FINAL ENVIRONMENTAL IMPACT STATEMENT

WOLF RIDGE CORPORATION MINE PLAN FOR A NAHCOLITE SOLUTION MINE

U.S. Department of the Interior
Bureau of Land Management
White River Resource Area
Craig District, Colorado

**2. PUBLIC COMMENTS ON THE DRAFT
EIS AND RESPONSES TO COMMENTS**

FIGURE 3-2

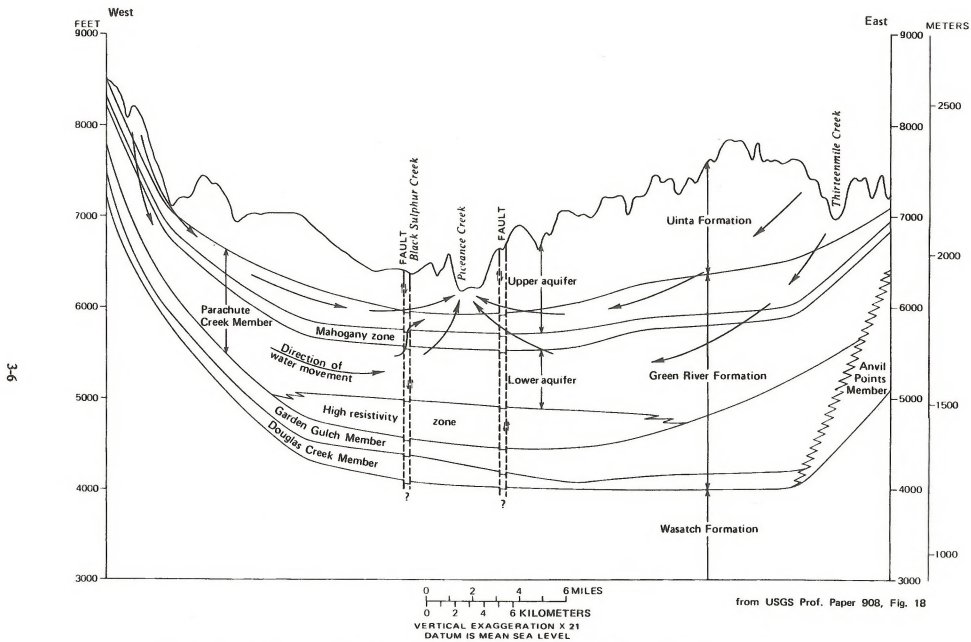
- p. 3-12 What is meant by, "Flow in the lower aquifer is towards a sink" and the "characteristics of any flow out of this sink are unknown"? As Figure 3-2 and Page 3-9 note, there is flow out of the lower aquifer with discharges to Picoance and Yellow Creek. This appears consistent with EPA's understanding of the regional hydrogeology. We suggest that these references to a ground water "sink" be deleted from the final EIS since they appear to conflict with the other conclusions about the discharge of flow from the Basin. 60

General Stratigraphic Column of Uinta Formation and Upper Green River Formation
FIGURE 3-1A

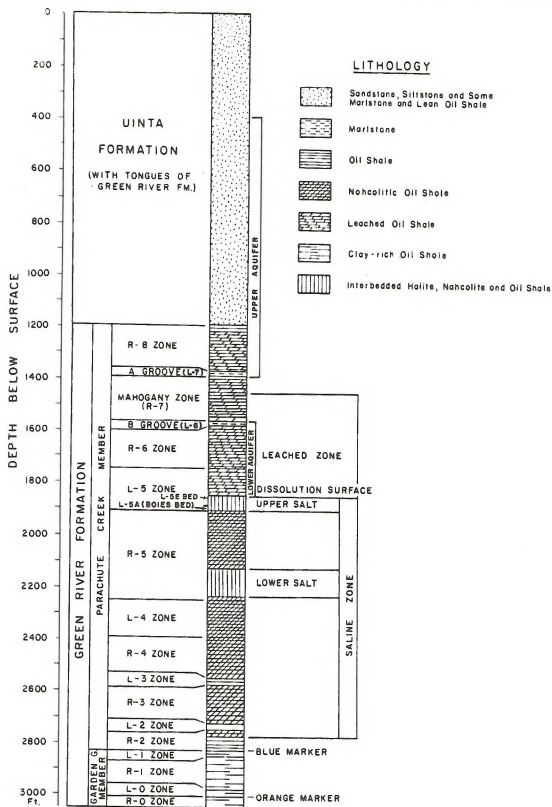
Only a 40 foot interval appears to be suitable for underground mining.	
3-7	Figure 3-1A			The leached zone should extend up to the top of the R-8 zone and the lower aquifer should extend up to the middle Mahogany zone as depicted in exhibit B. This	43, 44

Response No. 43. No change. Figure 3-1A is a generalized, stratigraphic column and was used to give the reader a general idea of where the oil shale zones and aquifers are located. Inclusion of additional, site-specific profiles were not deemed necessary or appropriate for the purposes of this document. However, more detailed information is available for review at the White River Resource Area office.
